MONTGOMERY COUNTY HISTORIC PRESERVATION COMMISSION
STAFF REPORT

Address:	8000 Overhill Rd., Bethesda	Meeting Date:	11/13/2019
Resource:	Contributing Resource Greenwich Forest Historic District	Report Date:	11/6/2019
Applicant:	Amil Gupta Mark Kramer, Architect	Public Notice:	10/30/2019
Review:	HAWP	Tax Credit:	n/a
Case Number:	35/165-19-D (Continued)	Staff:	Dan Bruechert
PROPOSAL: Porch Enclosure

Figure 2: The October 23rd proposal (right) and the current revision (left).

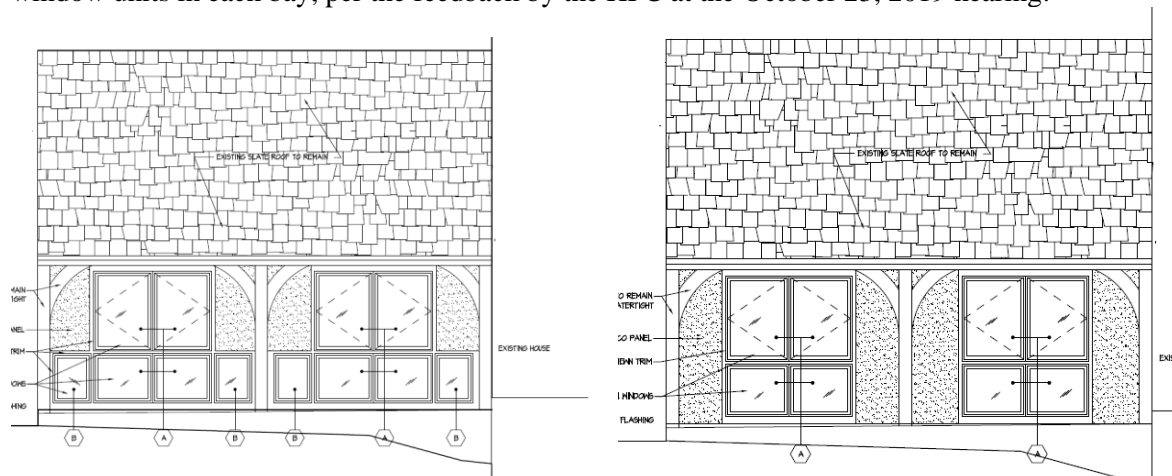
The applicant proposes to enclose the existing porch with a combination of Marvin windows, matching the frame details of the approved replacement windows,³ and stucco fiber cement panels. The revised window configuration consists of a pair of low, fixed windows with two larger casement windows above in each of the two bays on the north and south elevation. This revision has eliminated two lower, fixed window units in each bay, per the feedback by the HPC at the October 23, 2019 hearing.

The east elevation will have a pair of French doors, flanked by fixed sidelites and fiber cement stucco panels. The windows and fiber cement panels will be installed so that they are flush with the interior walls, not centered in the openings. Several Commissioners pointed to the treatment of this elevation as having the desired balance requested in the north and south elevations. The treatment of the east elevation leaves a maximum amount of structure exposed. Additional structural elements will be constructed on the interior of the porch. While there is no stucco on the porch in its current configuration, this treatment is present on limited areas elsewhere on the house. Stucco is a material commonly applied to Tudor Revival style architecture, and its inclusion on the side porch will not introduce a new material

Based on Staff's analysis and the feedback presented at the October 23, 2019 HPC meeting, Staff supports approval of the revised design under the *Design Guidelines*, Standards 2 and 5 of the *Secretary of Interior's Standards for Rehabilitation*, and Chapter 24A-8(b)(2).
